Date: 5-22-14

2014 Draft Environmental Impact Statement for the Proposed 2013 Master Plan for the National Institutes of Health Bethesda Campus which was reviewed without the DEIS as MR No. 2013005 on 10-18-12. Bethesda Chevy-Chase Master Plan.

This is a review of the Draft Environmental Impact Statement (DEIS) for the new master plan for the National Institutes of Health Campus in Bethesda. This federal facility is located on Wisconsin Avenue. It is the largest employer in Montgomery County with 20,262 of its workers located at this Bethesda Campus. The campus is 310 acres in the R-60 zone within the Bethesda-Chevy Chase Master Plan area. The population of the Bethesda campus is anticipated to expand by 3,000 workers during the time frame of this new plan. That will bring the total number of works at this campus to approximately 23,000.

Figure 3-8: NIH Stream 100-Year Floodplain

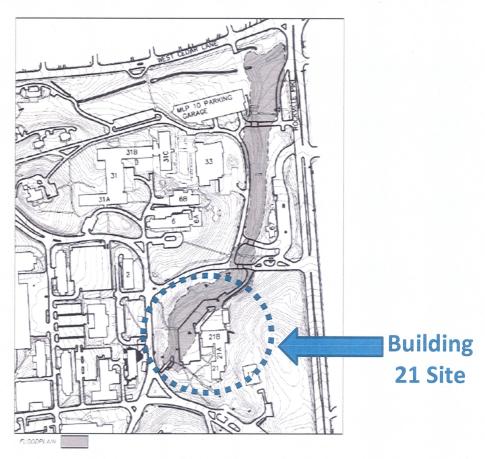
- 13. Locate the future Administration Building which is proposed for the site of existing Building 21 where both the new building and associated impervious areas are outside the floodplain. If avoidance of the flood plain is not feasible, mitigation and permitting measures must ensure that no off-site increases to the floodplain water surface elevations occur.
- 14. Include stream protection measures during the demolition of Building 21 and its parking lot.
- 15. Provide stream protection buffers along Stoney Creek.

16. Provide measures of protecting the base flow of the spring that has been contained and piped under a vault beneath existing Building 21. This is important to do during the planned demolition of Building 21. Consider day-lighting the spring and associated stream along the eastern edge of the NIH property.

The Proposed Action, which has already been selected, shows the construction of a New Administration Building at the location of existing Building 21. The building abuts the floodplain while the parking lot is within the floodplain. This raises issues concerning flooding as well as stream protection.

Exhibit 6.2.C. Recommended Maximum Building Heights

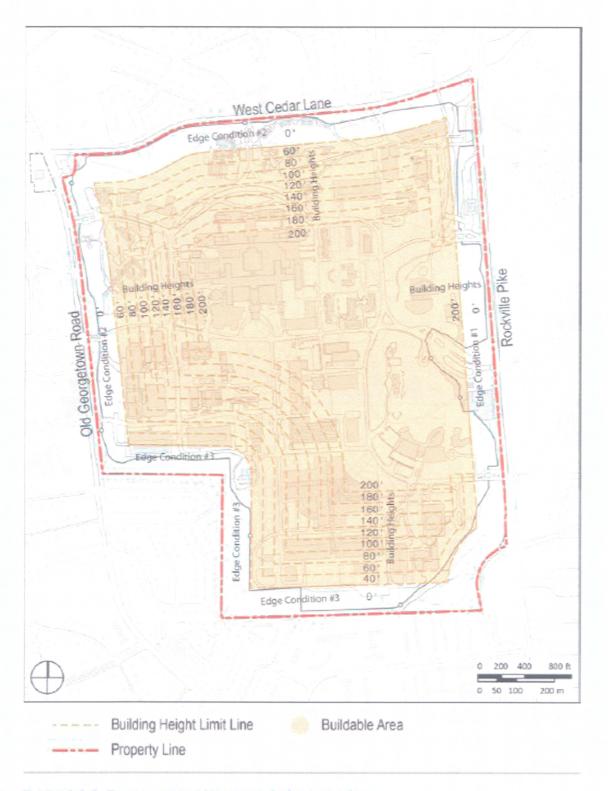
The proposed administrative building on Wisconsin Avenue is a concern due to its height and proximity to Wisconsin Avenue. The compromise of the views from Wisconsin Avenue are also a concern. While NIH has a standing streetscape plan for its side of Wisconsin Avenue, there are gradual changes being made that compromise the character. With this in mind, more direction should be included concerning improving the appearance. This could include additional green buffers to reduce the visual impact of the security facility for truck inspections, for example.

• Provide more direction in the plan to improve the appearance of Wisconsin Avenue, particularly relative to height limits and buffering for the proposed Administration Building and all security screening facilities. .
